Appeal NO: ABP 314485-22Defer Re O/H ☐Having considered the contents of the submission (dated) received 02/04/2024
fromSMTW Environmental DAC I recommend that section 131 of the Planning and Development Act, 2000
be (not) be invoked at this stage for the following reason(s): no new material issuesE.O.: Pat BDate: 19/04/2024

**RE: FURTHER INFORMATION PROVIDED TO AN BORD PLEANALA BY THE DAA
ON PLANNING APPLICATION F20A/0668**

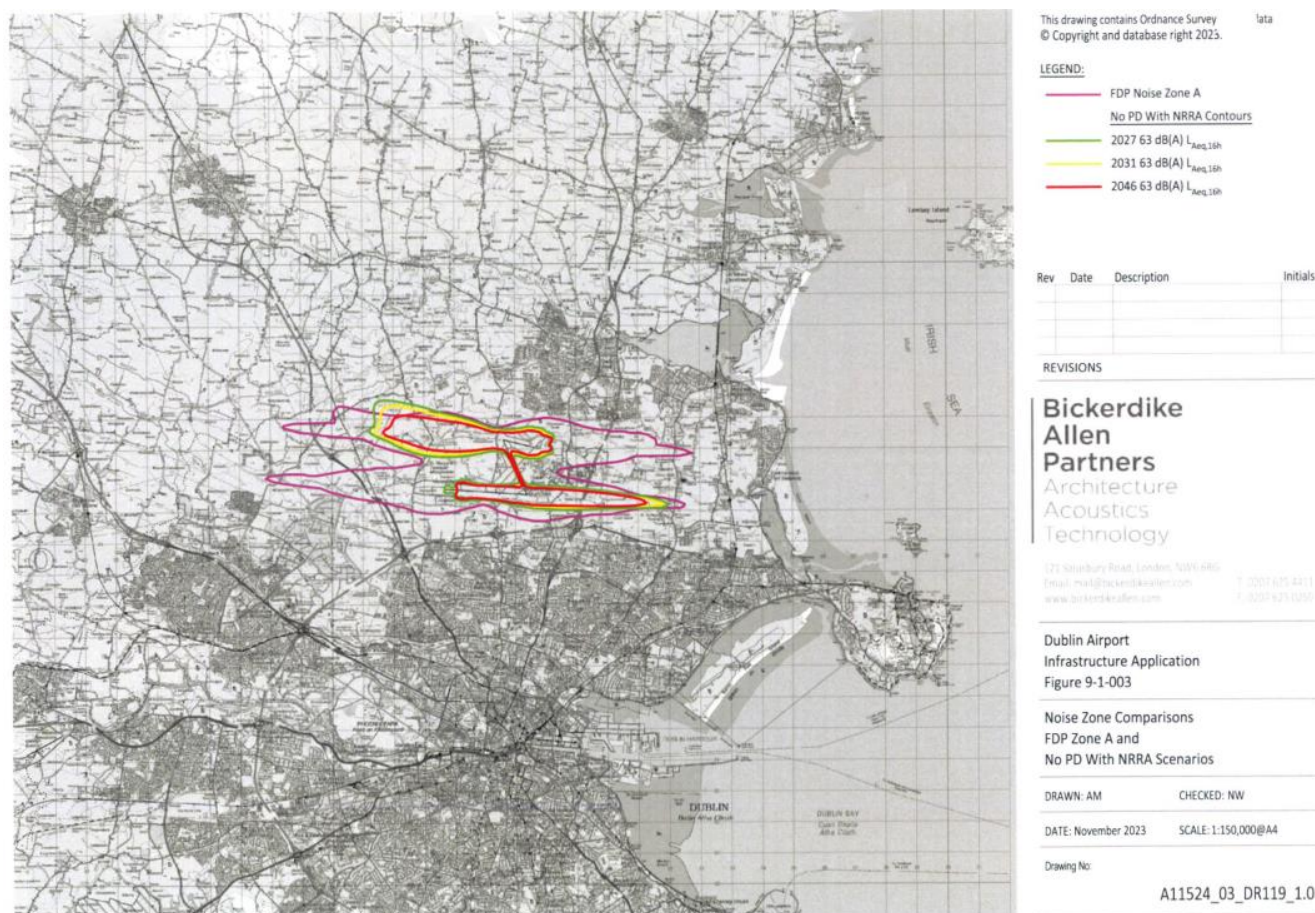
Figure 9-1-003 shows that the 2027 63 dB LAeq16 contour for 'No Proposed Development (PD)' and 'With North Runway Relevant Action (NRRA)' lies outside Zone A of the Development Plan. The 2027 No PD With NRRA scenario is equivalent to the 2025 Proposed scenario in the Relevant Action as it has the 32m passenger cap in place and Relevant Action in place. This map shows that the current flight operations do not comply with Noise Zone A. The same is true for Zone B and Zone C.

However, it is worth pointing out that the contours in the figures in Appendix 9-1, section 9-1.8 are not modelled on the same basis as the Development Plan Noise Zones. The Development Plan Noise Zones are single mode, based on 100% modal usage of each runway in each direction. The Noise Zones attempt to capture the worst-case scenario on any given day. They are a summation of 100% departures on each runway (10L, 10R, 28L and 28R) and 100%

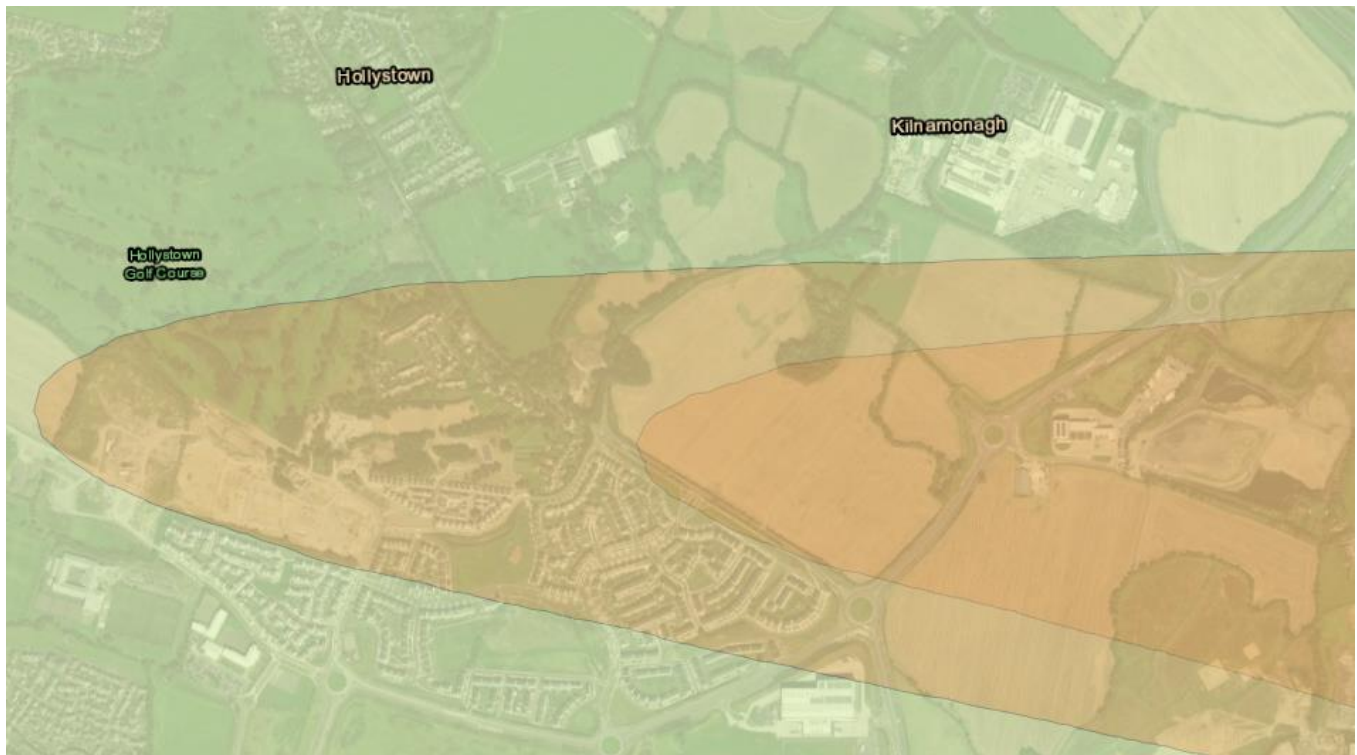
Below is a comparison of the Night contours for 2022 and 2023. It is evident that the 2023 contours are larger than the 2022 contours.

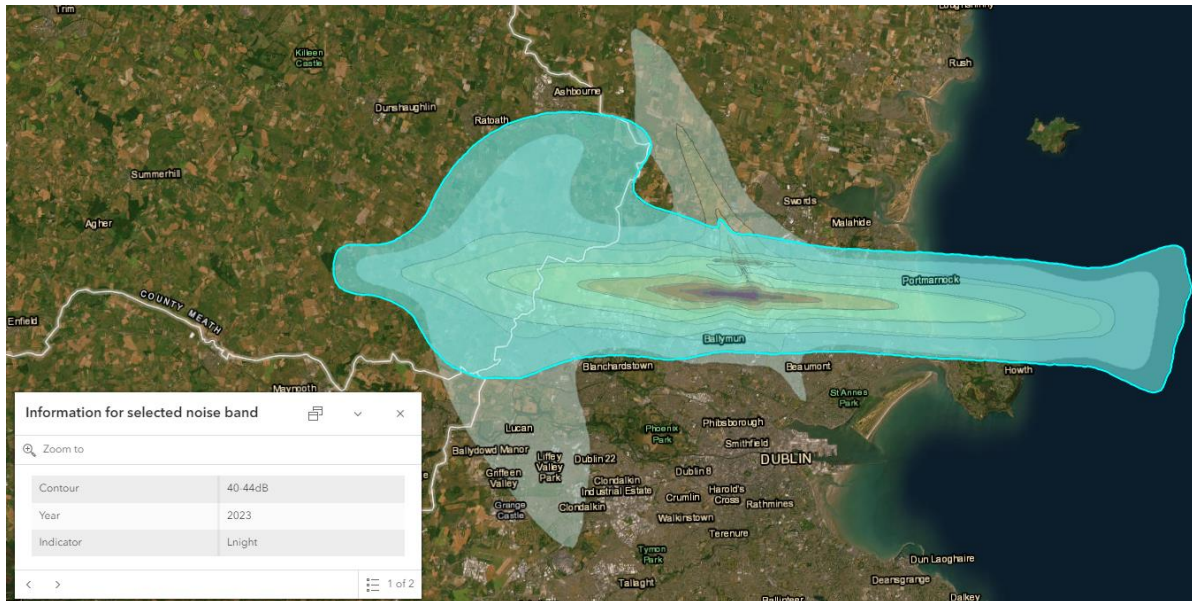
Below is an image of the 2023 Lnight contours superimposed on the 2019 Lnight contours.

From the image one can see that in 2023 a greater area to the North-West of Dublin Airport was exposed to greater than 55 dB Lnight. The image also shows that the contours extended on both ends of the South Runway in 2023.

Figure 18 – 2022 55-59dB noise contour (L_{night})

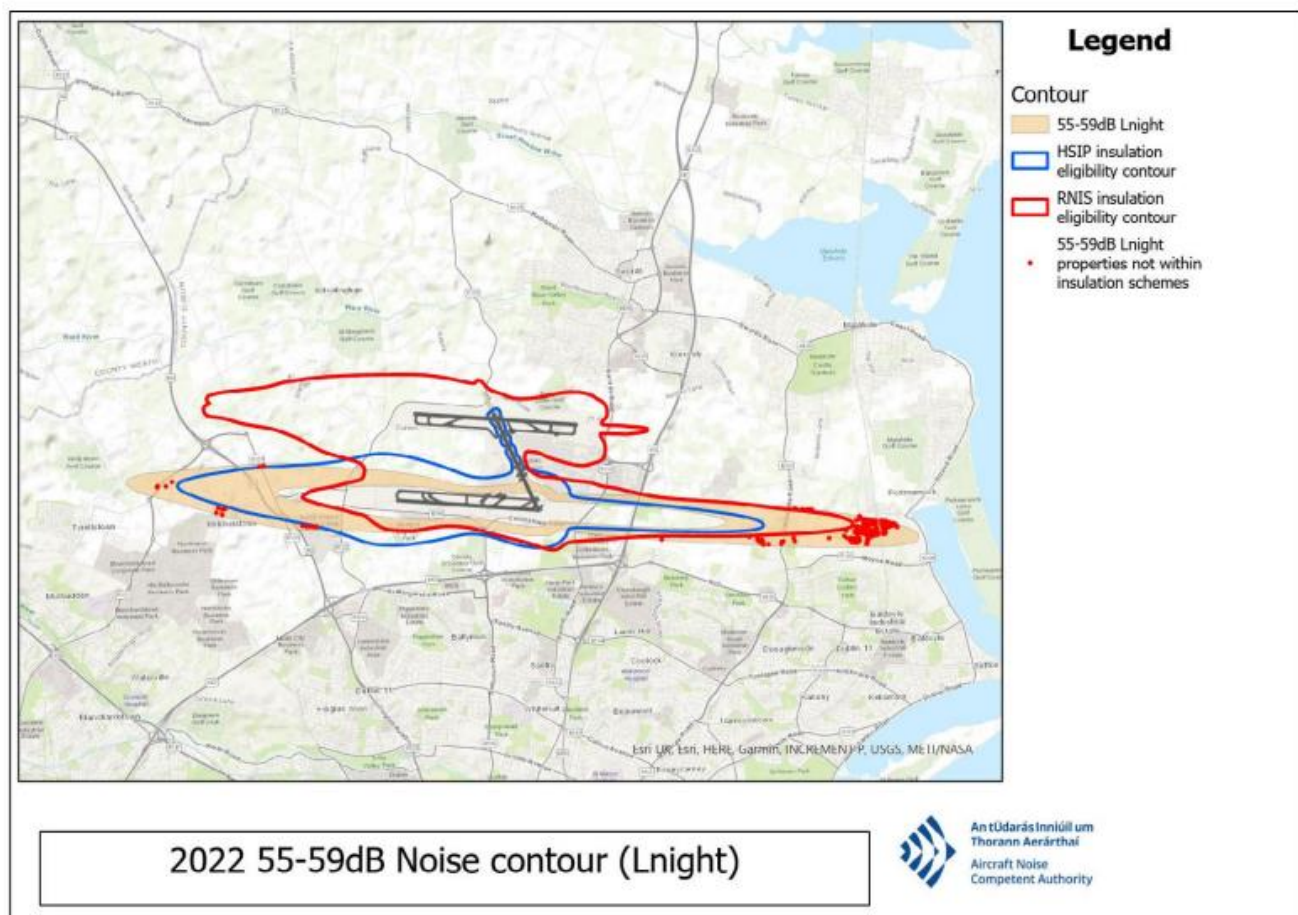
From Figure 18 it is evident that the majority of dwellings were in South Portmarnock near the train station and directly under the South Runway flight path. It is worth highlighting that in 2022 there were only 210,490 aircraft movements compared to 238,002 in 2019, yet there were 7% more nighttime flights in 2022.
